ADDENDUM NO. 5

**CONTRACT RFB-RC-SWR-CIP 2020-02
MAIN PUMP STATION UPGRADE PROJECT**

**ROCKLAND COUNTY SEWER DISTRICT NO. 1
ROCKLAND COUNTY, NEW YORK**

September 8, 2021

DRAWING TITLE: **DOOR DETAILS**

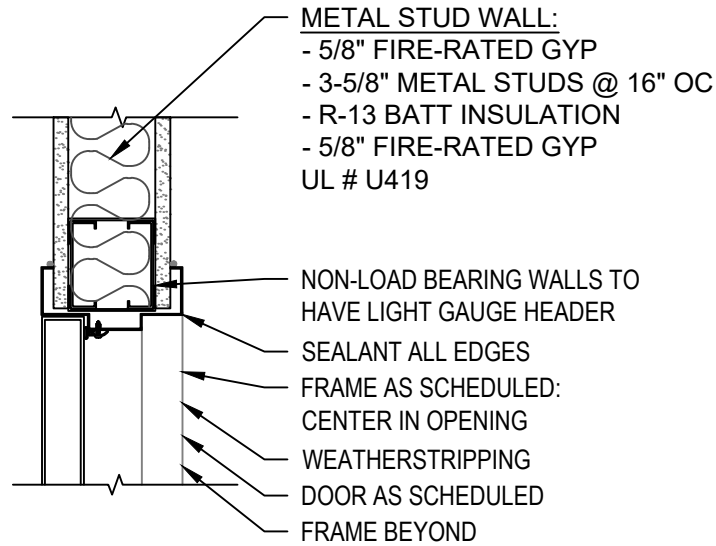
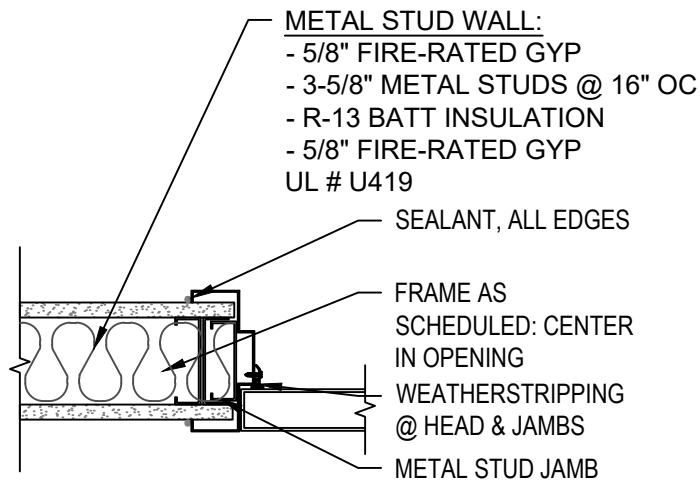
DH3, DJ3, and DS3 are all reference on the door schedule, but they don't appear on any drawings. Is this a mistake or are there are details to be provided?

Sheet A-001 – Add detail DOOR DETAILS FIG-1 and FIG-2 as shown on Attachment 1.

On Sheet A-001, Add detail DOOR DETAILS FIG-1 and FIG-2 as shown on Attachment 1.

DIVISION CHAMBER
PLANS, SECTIONS AND DETAILS
Scale: 1/4"=1'-0" Date: AUG 1984 DWG. NO. 146-0

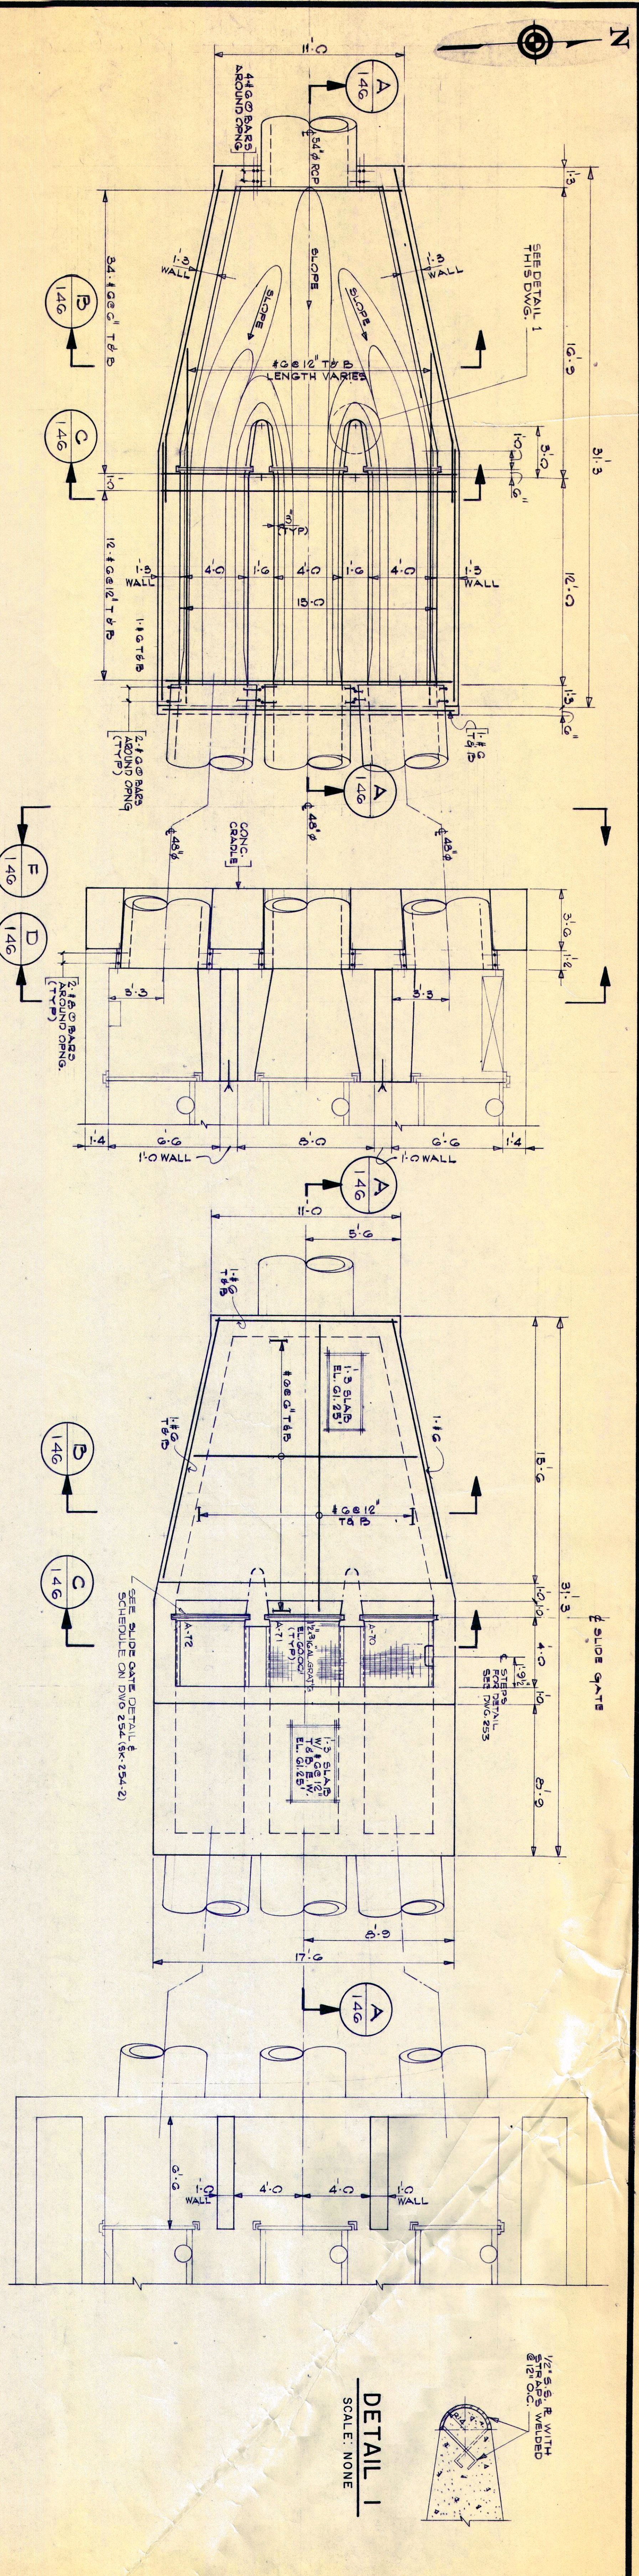
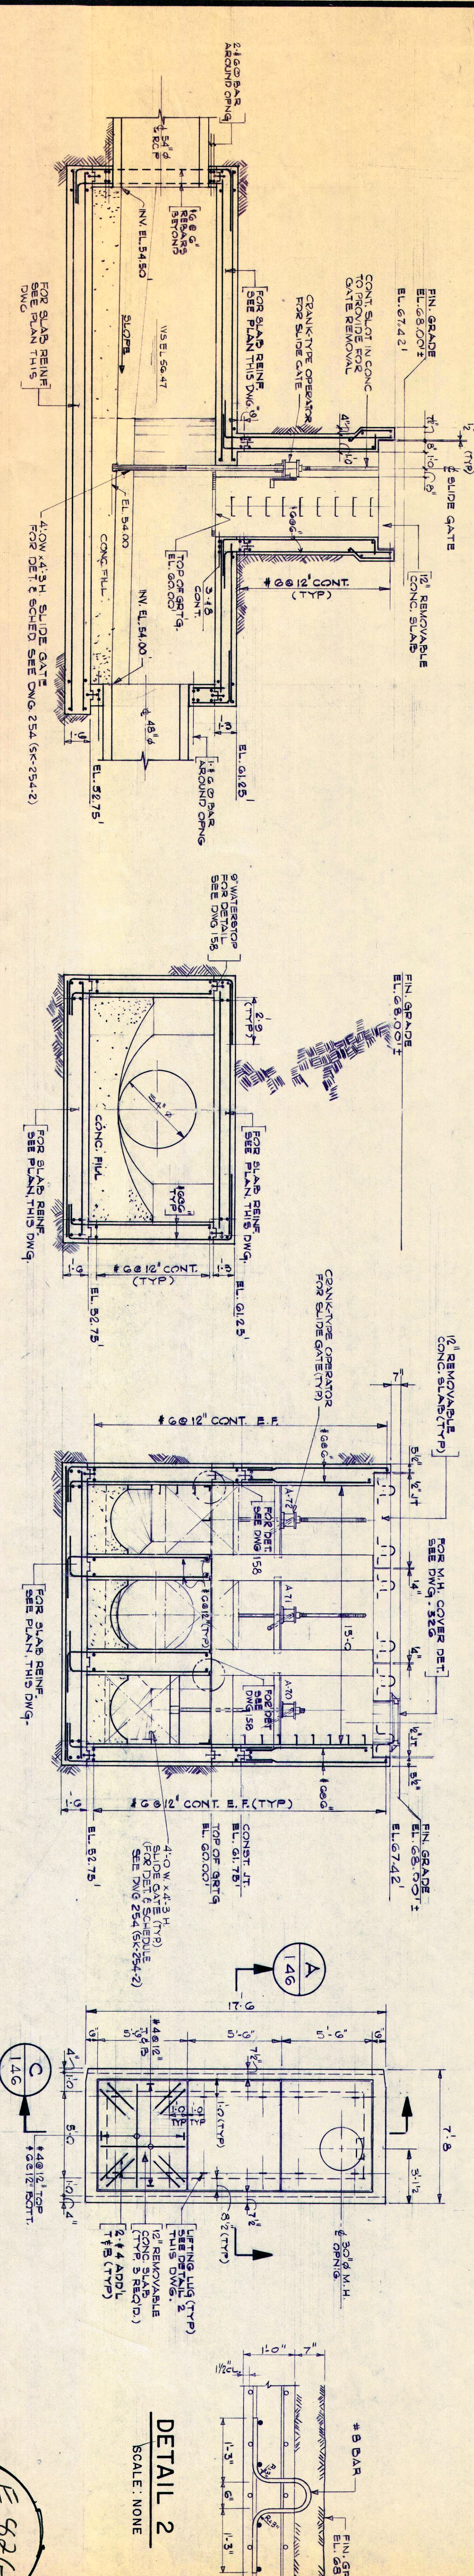
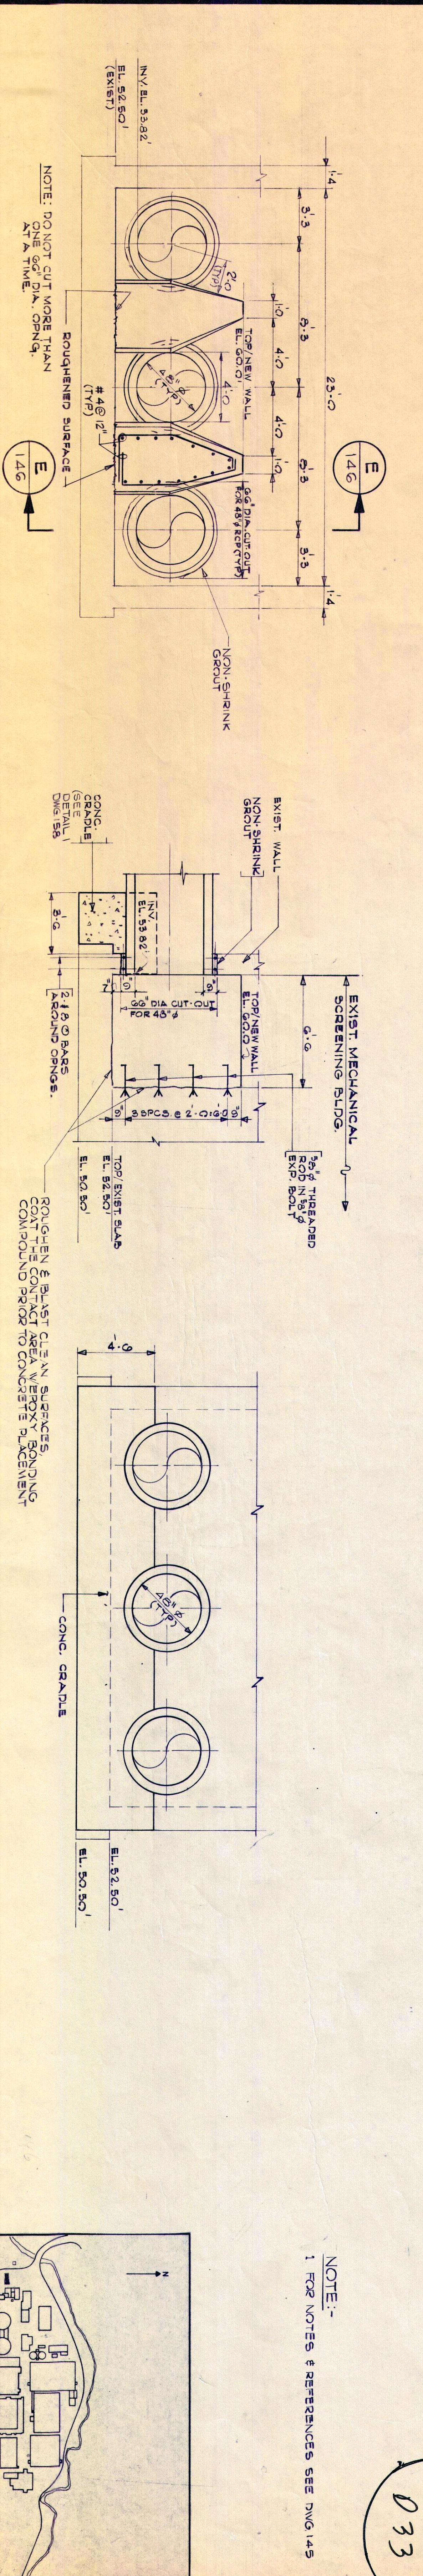
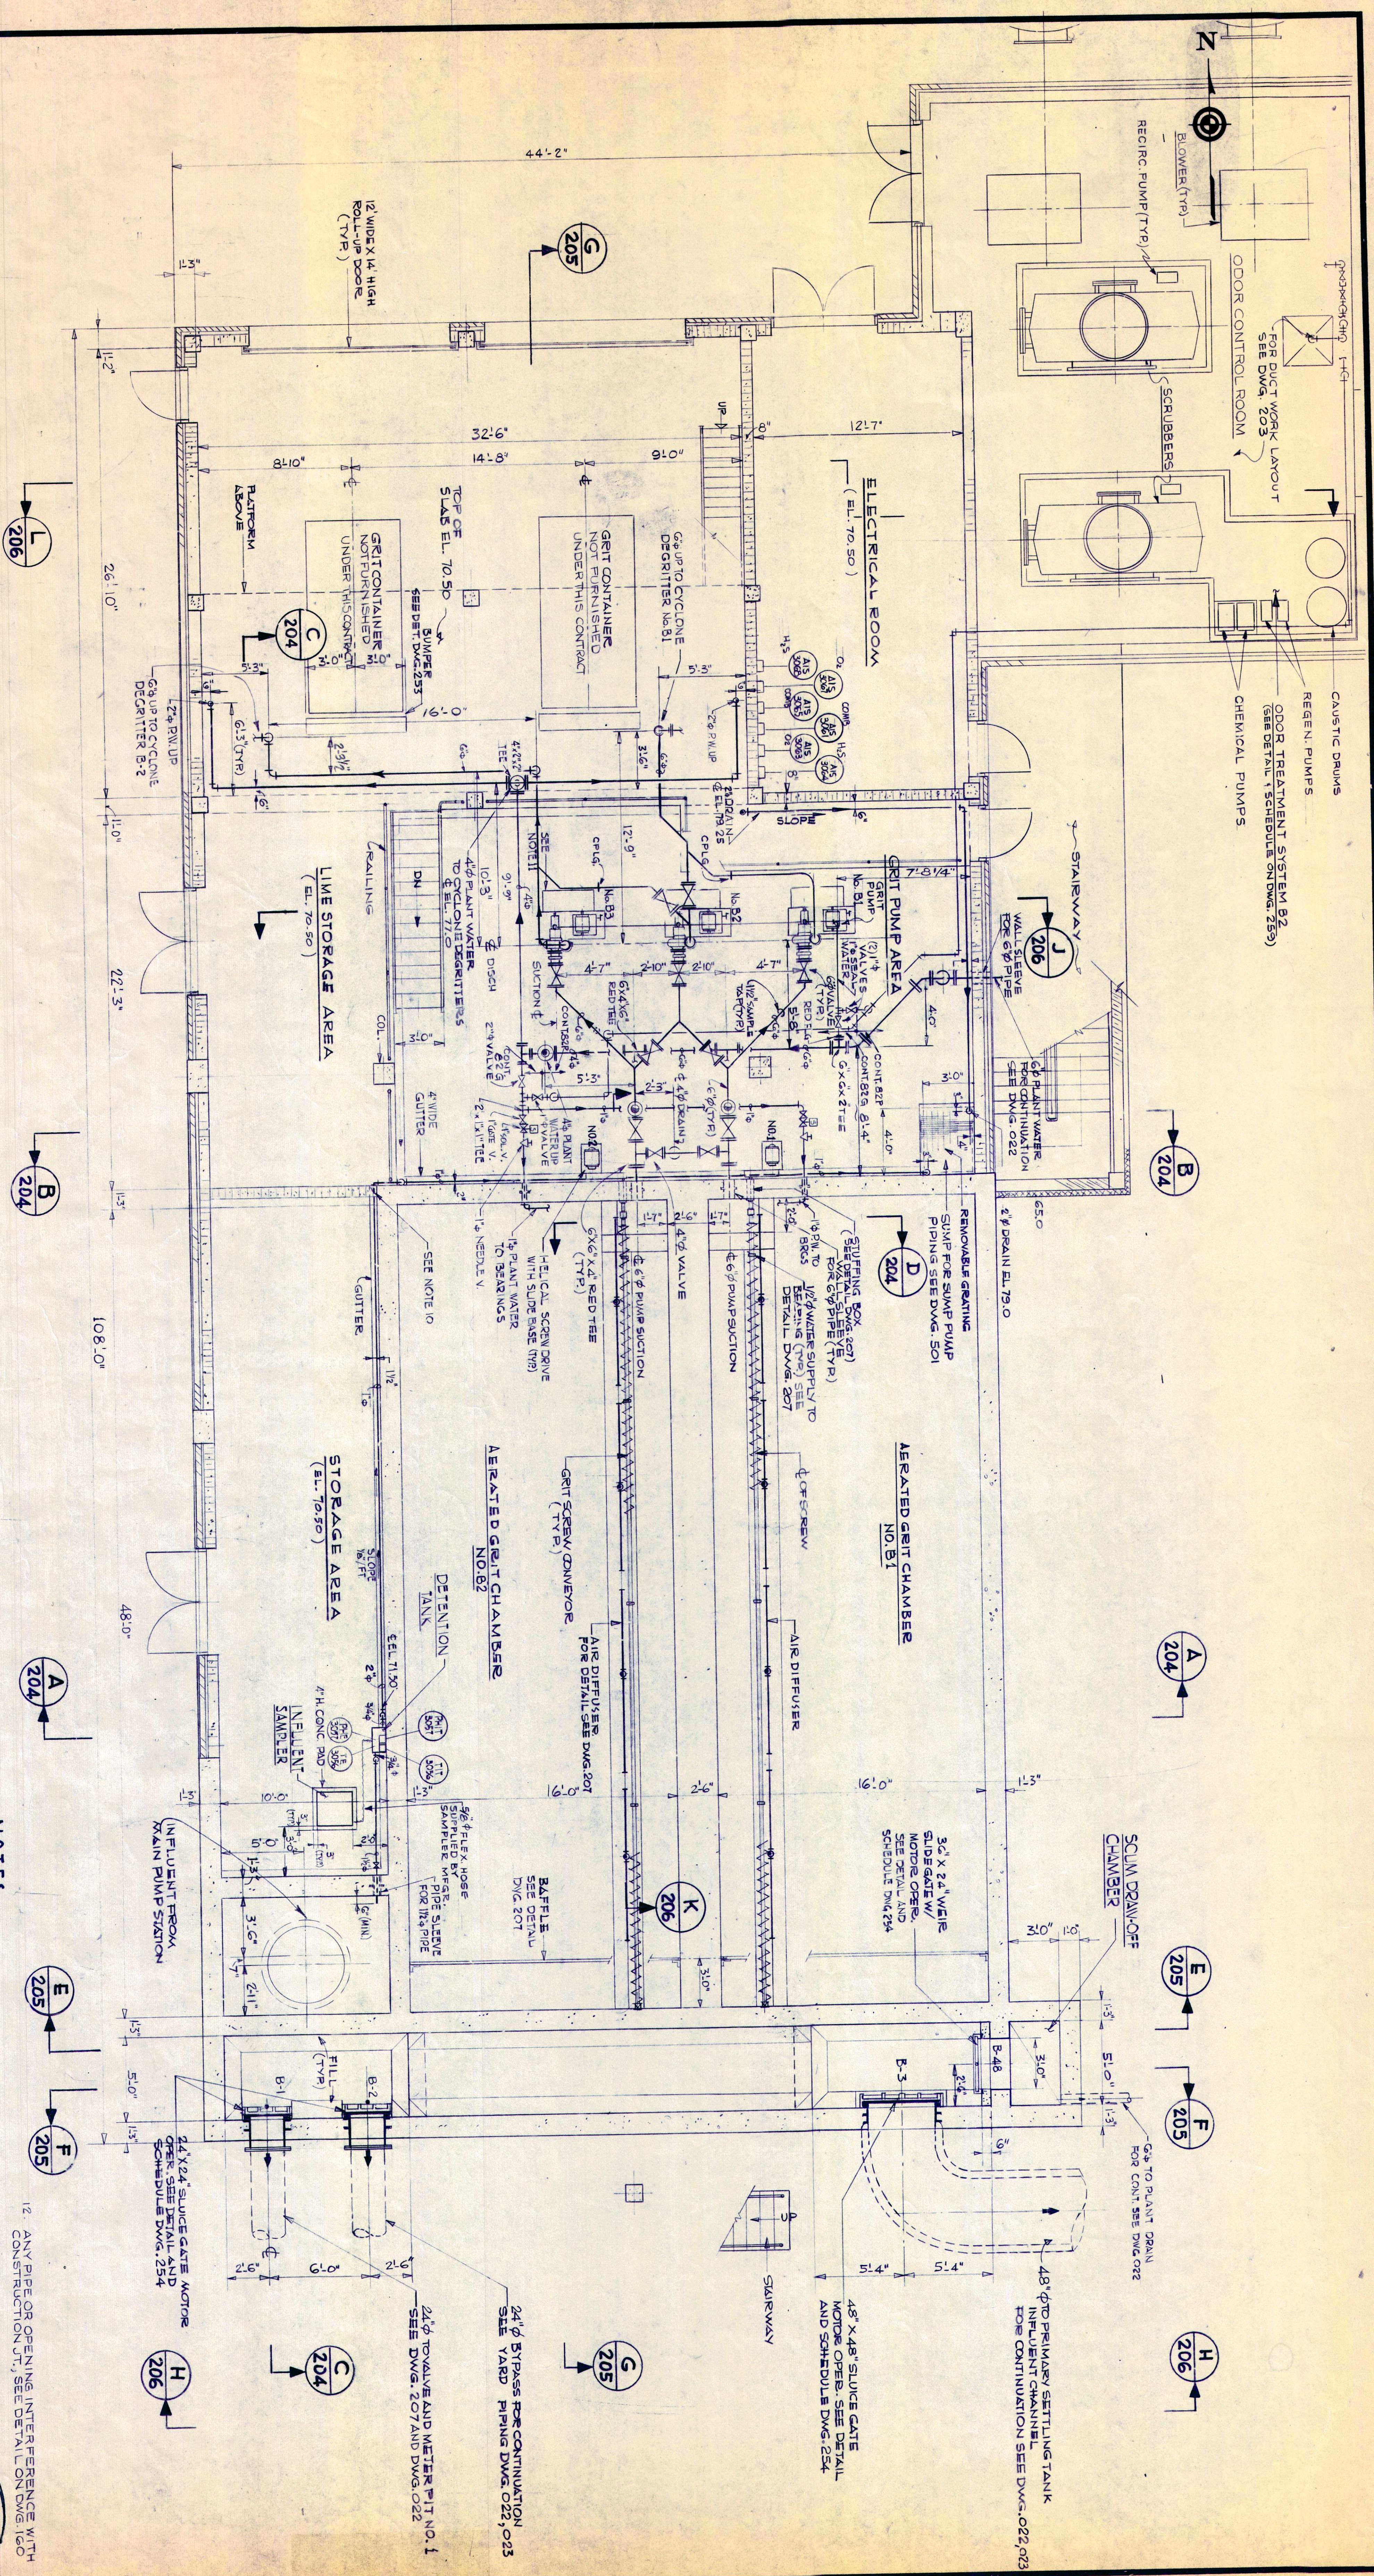
From the additional drawings provided in Addendum #2, we are unable to determine the following information related to the Grit Tanks Influent Channel upstream of the Parshall Flume in the Grit Building:

- a. Channel width
- b. Channel depth
- c. Normal water depth

Please provide this information as it is necessary in order to determine the bulkhead required during bypass operations.

See Attachment 2 - Contract 82 Vol II Drawings. Water depth is dependent of flow from the main pump station.
